COMMENTS ON THE DRAFT EIA REPORT: PROPOSED NEW CBD BYPASS ROAD IN HERMANUS (DEA&DP Ref: 16/3/1/2/E2/15/2124/14)

Please find the comments of the Hermanus Ratepayers Association on the Draft EIA Report.

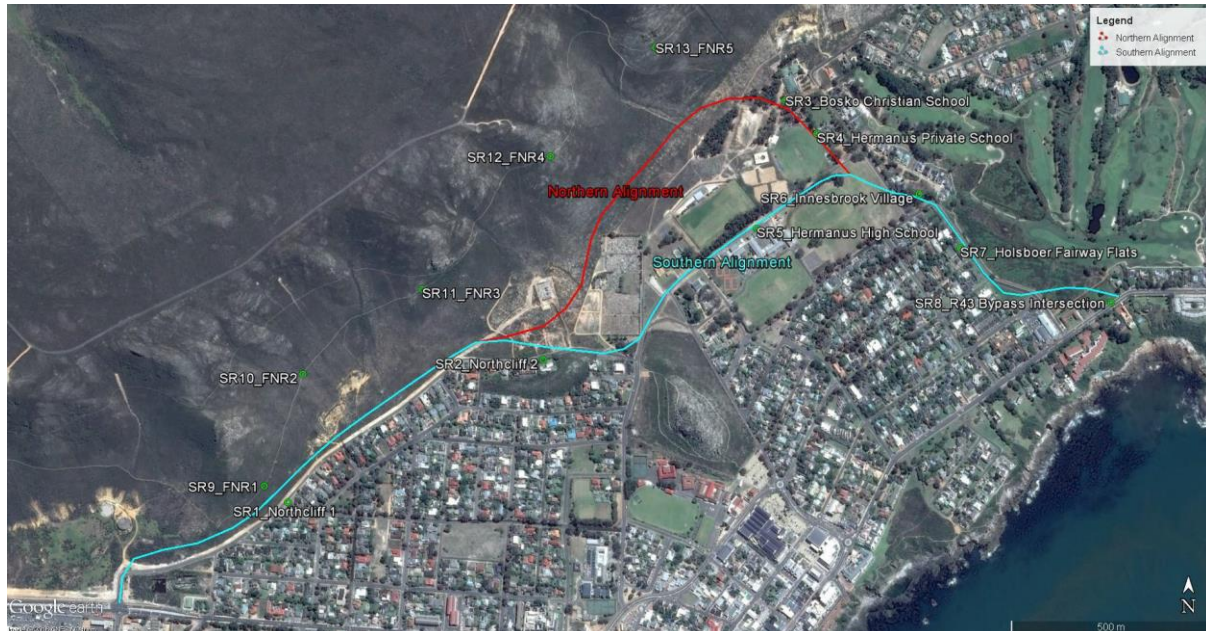
In the Draft EIA Report Annexure relating to Noise, forecast noise levels along Mountain Drive, next to Bosko, the Private School, Innesbrook Village and Fairways Avenue are way above acceptable levels.

To quote from the report *“The day time noise levels at SR10 and SR12 are expected to increase by 3.8 dB(A) and 4.7 dB(A) respectively, which constitute a **Noticeable Adverse** impact. It is expected that due to the implementation of the northern bypass alignment, SRs 7, 9 and 13 will experience day time noise level increases of between 5 and 10 dB(A) and therefore **Considerable Adverse** impacts. Finally, **Major Adverse** impacts are expected to occur at SRs 3, 4 and 6 which could*

undergo up to 20.8 dB(A) (SR4) increases as a result of the new alignment.” Where the various receptor locations are indicated below.

Potential mitigation measures such as low noise surfacing, noise barriers, reduced speed limit and thermal glazing are discussed but the critical missing components are

- (1) exactly what mitigation measures are proposed, and where?
- (2) what will the forecast noise levels be once the mitigation measures are implemented?
